CITY COUNCIL ACTION FORM

DEPARTMENT	PRESENTED BY	DATE
Planning	Kathryn Dunleavy - Planner	March 15, 2022

First Reading and Setting a Public Hearing of Ordinance 2022-06: An Ordinance Approving a Major Impact Review for a 0.60 Acre Parcel Located at 323 West First Street Currently Zoned Commercial (C-1) and Industrial (I) and Within the Hwy 291 Established Residential Overlay, to Place a Planned Development Overlay on the Property and Approve the Development Plan and 16-Lot Major Subdivision for Residences at Salida Bottling Company.

ILLUSTRATION OF THE PLANNING COMMISSION CONDITIONS OF APPROVAL FOR BUILDING HEIGHT & STORIES DEVIATIONS:
(Agreed to by the applicant and incorporated into the PD Plan.)

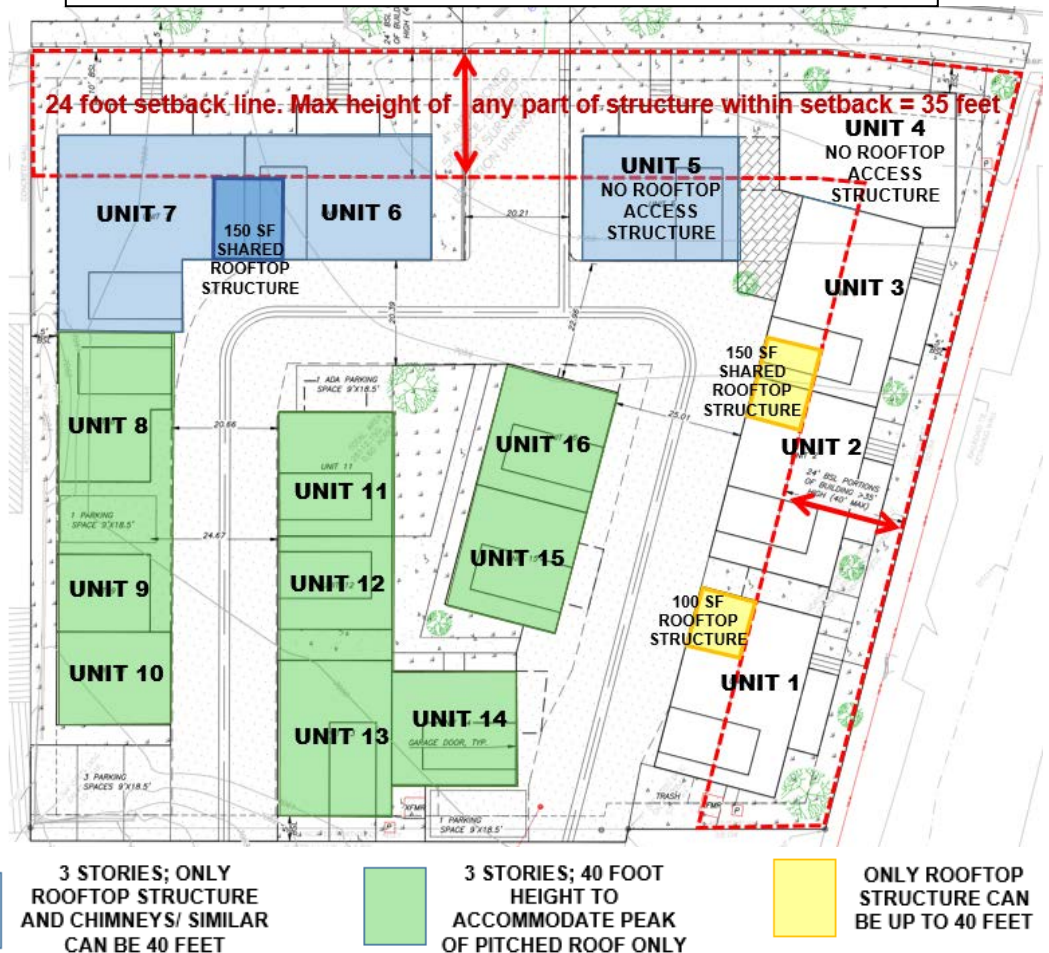
Units 1-4 Units 1-4 are proposed the allowed 2 stories for the majority of the structures. A deviation was requested for Units 1-4 to locate a rooftop access structure on each, limited to 100 sf per unit, with a maximum height of 40 feet to the highest point of the structure.

Staff recommended that the request be limited to the minimum necessary to allow rooftop access and only where it will not potentially obstruct prominent view corridors from downtown. Therefore the following limitations were recommended: rooftop access on Units 2 & 3 be allowed only as one combined structure at a total of 150 sf and that no rooftop access structure be allowed on Unit 4 due to the higher visibility of that location from downtown and the potential obstruction of prominent viewsheds.

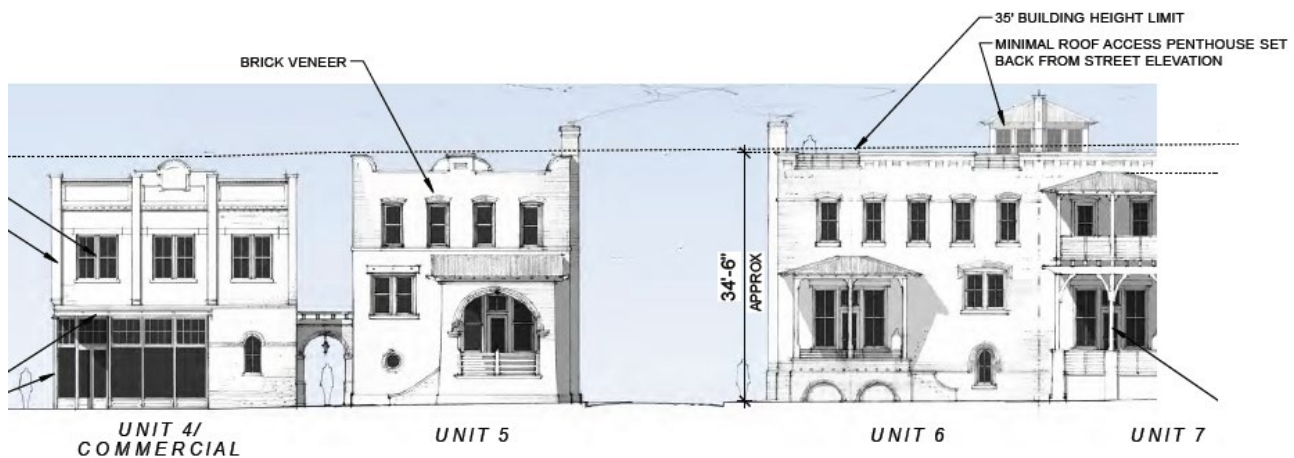
Units 5- 7 (in blue on the site plan). The applicant is requesting a deviation to allow Units 5-7 to be 3 story buildings. The proposed maximum height of the 3 stories is 35 feet, which does not require a deviation. However, a deviation is requested to allow a rooftop access structure, limited to 100 sf per unit, to be a maximum of 40 feet at its highest point. Additionally, the applicant has requested an allowance for chimneys up to 40 feet. (see building cross-section to right illustrating proposed rooftop access structure and chimney height)
